19-283 WATER LANE, ANGMERING, WEST SUSSEX

Subject: Site Inspection

Photograph 1 (above). G62, elm, removed located to the west of the main site entrance. Viewed looking towards the north-west.

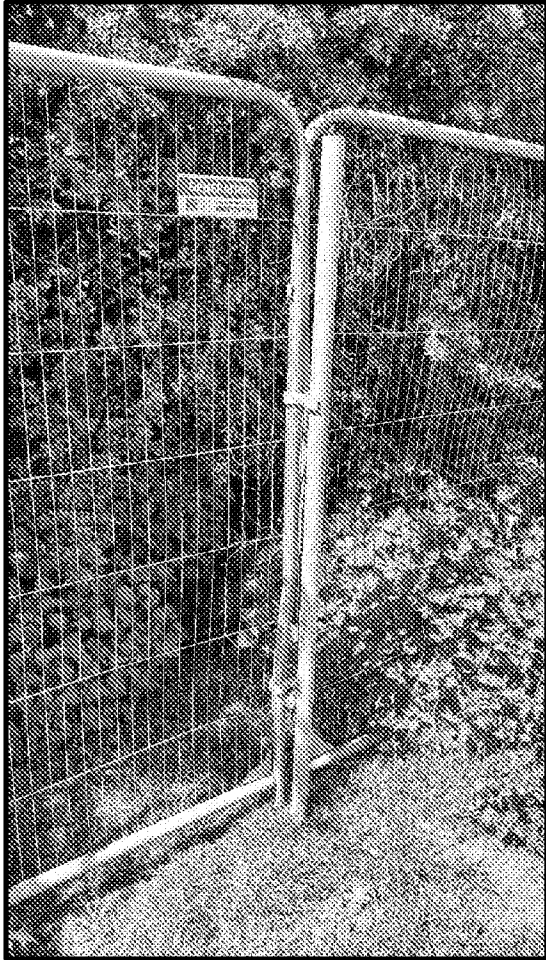
- 2.1 Tree removal of G62 (**Photograph 1**), G23 - G25 & T26 - T30 (**Photograph 5**) and H42 and G15 (**Photograph 17**) has taken place satisfactorily.

Photograph 7 (above). Tree protection fencing along the northern section of the western parcel of land around T4. Viewed looking towards the north-west.

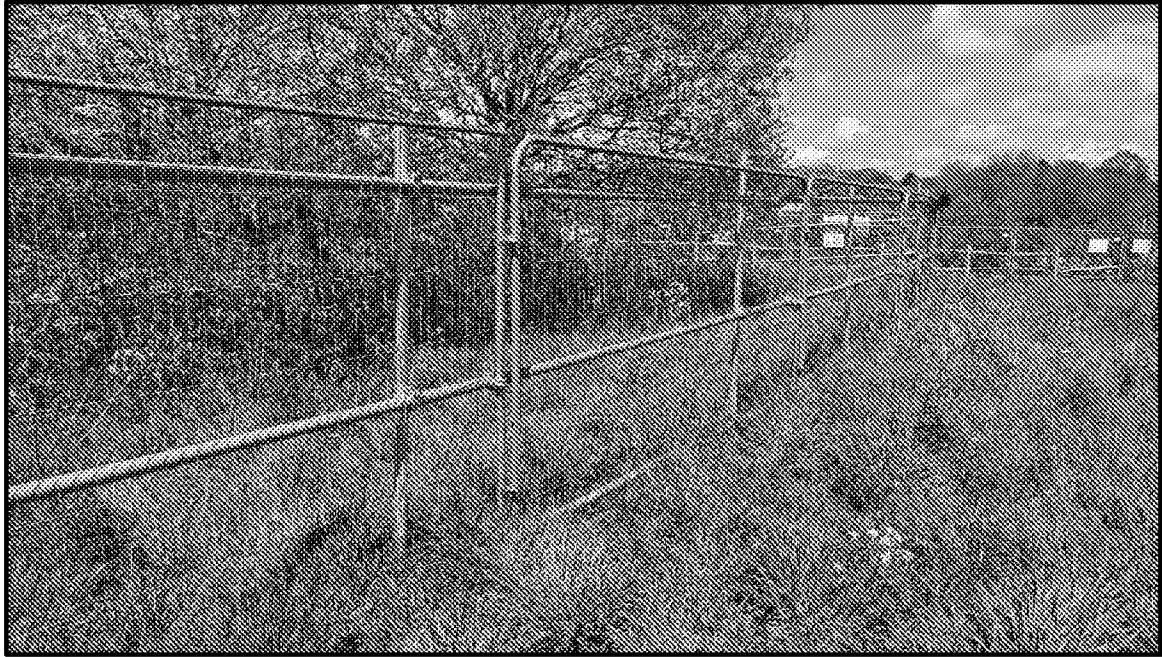
proximity of work taking place around the retained trees. (**Photographs 5, 6, 7, 8, 10, 11, 12, 13 and 16**)
